AGENDA
PLANNING AND ZONING COMMISSION MEETING
CITY OF CREVE COEUR, MISSOURI
MONDAY, AUGUST 21, 2017
6:30 PM

2. Application #17-026: Public Facilities Site Development Plan for the New Police Station Building at the Creve Coeur Government Center , 300 N. New Ballas Road

APPLICATION TO PLANNING AND ZONING COMMISSION #17-018 TEXT AMENDMENTS TO ARTICLE VIII SIGN REGULATIONS OF THE ZONING ORDINANCE

Figure 6: Close-up of the Site Plan showing the proposed front entrance.

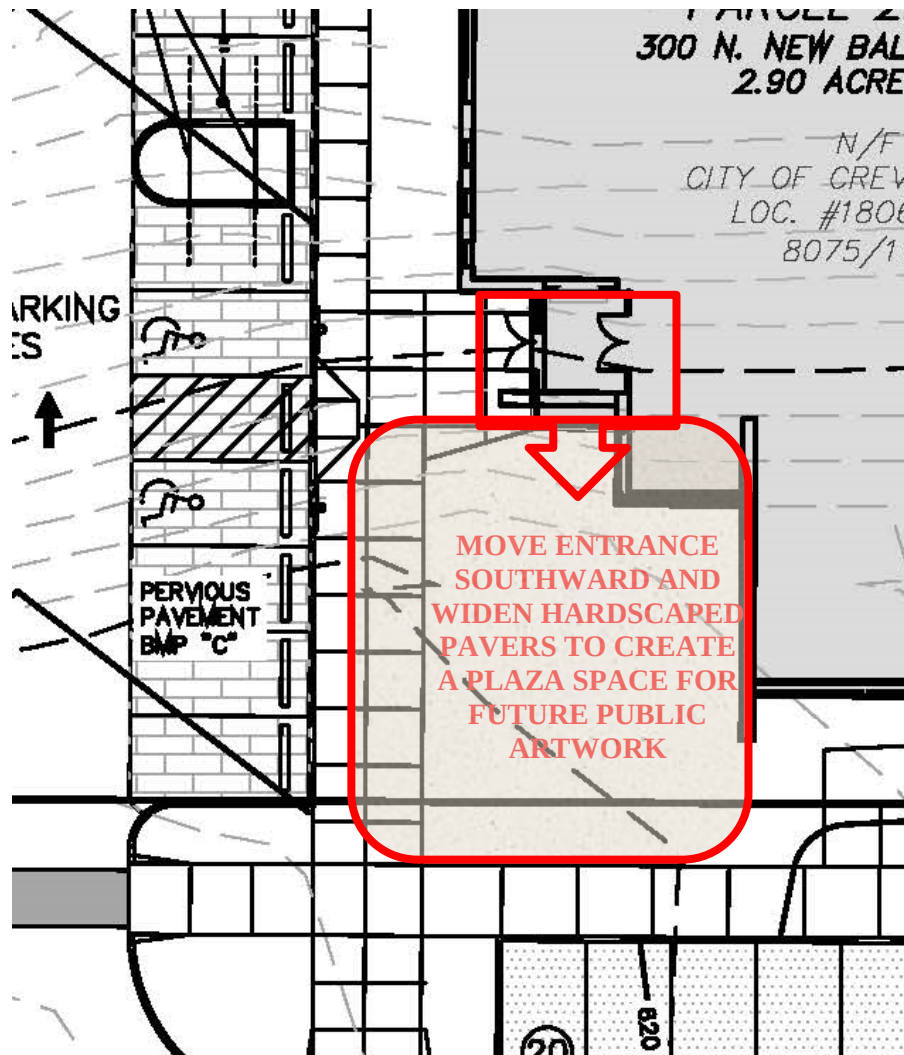
Further, the main entrance and plaza area in front of the building seems minimal where the doors should be reoriented within the glass area, instead of adjacent to the wall, and the walkway in front of the building should be widened to create greater presence and further the proposal toward the Design Guidelines. The proposed element includes a canopy that is only over grass area. Eliminating the vestibule wall and centering the entrance within the glass structure and thereby allowing the canopy to service the purpose, and widening the concrete pavers and thereby providing a future location for a sculpture to be coordinated with the Arts Committee may aid in the design of the building to the entry elements. Final design of the entry should be coordinated with the Arts Committee to determine the hardscape and landscaping needed to accentuate this element as a minor site plan amendment with approval by the Planning and Zoning Commission at a later date.

Figure 8: Close-up of the Proposed Landscape Plan with additional areas for planting along the west elevation/

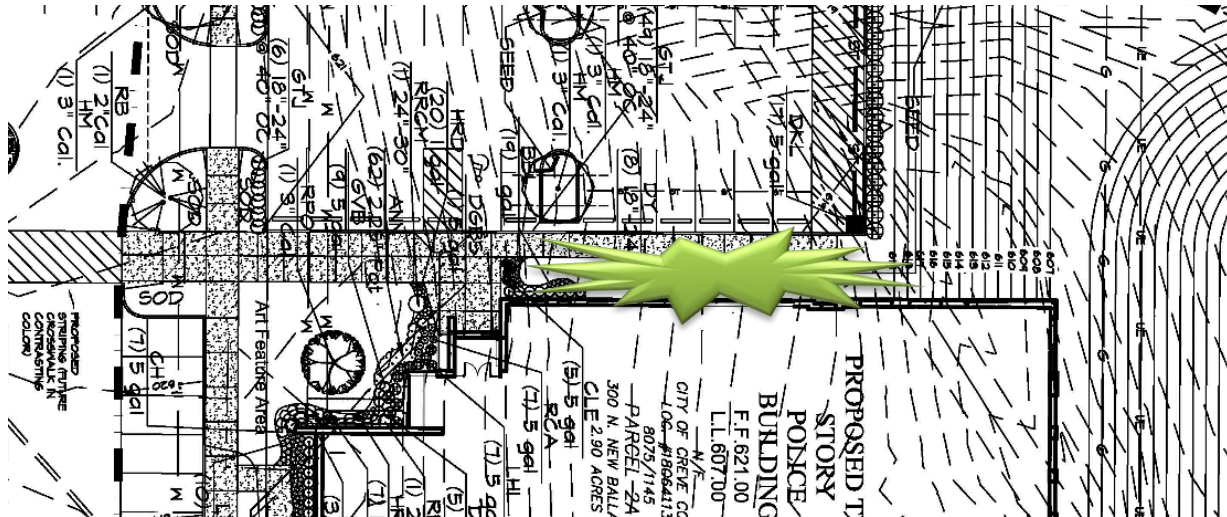
The proposed Landscaping meets with the recommendations of the Design Guidelines by providing designed landscape areas throughout the site. Further coordination with the renovation of the Government Center will coordinate with proposed landscape design. Staff recommends that with the wider patio area described above, the proposed landscape in front of the building could be shifted further along the elevations to soften the building in keeping with the Design Guidelines recommendations that strongly encourages high quality landscaping that accentuates the building and site, softens the effects of the parking. Additional plantings along the north elevation is recommended to screen the trash/and generator enclosures as discussed further below.
